SERVICE BULLETIN

NUMBER: M20-210

SUBJECT:

REPLACEMENT OF WHITMAN GENERAL VACUUM SWITCHES MODEL P118V-IN-K4L-2, AND P118V-IN-K5L-1 OR/AND U.M.A. VACUUM GAGE MODEL 3-200-3 WITH EDO-AIRE SWITCH P/N 22-1280-04

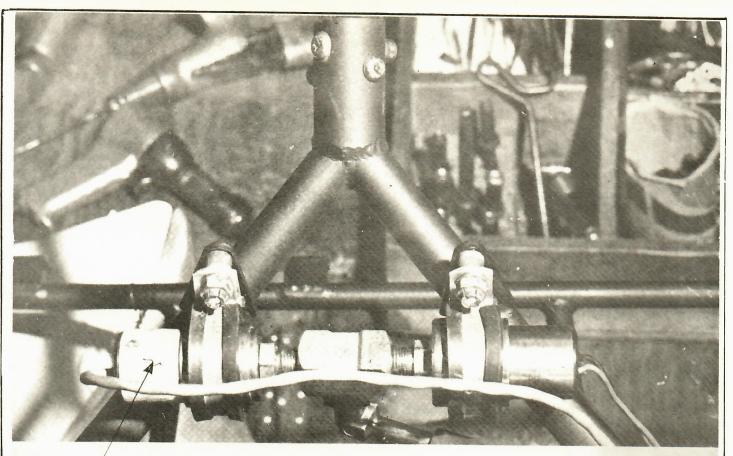
d.	e1	hi	ares	q1	Replace	11.
--	----	----	----	------	----	---------	-----

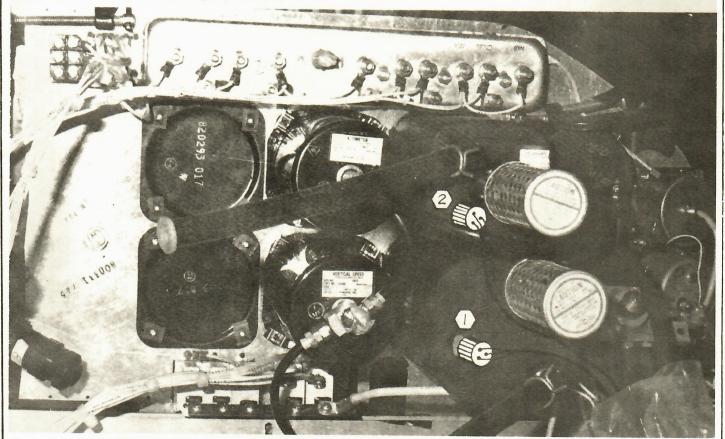
Remove Whitman General vacuum switches, clamps, hose, etc.

- (1) Install Edo-Aire vacuum switch.
- Alternate installation.
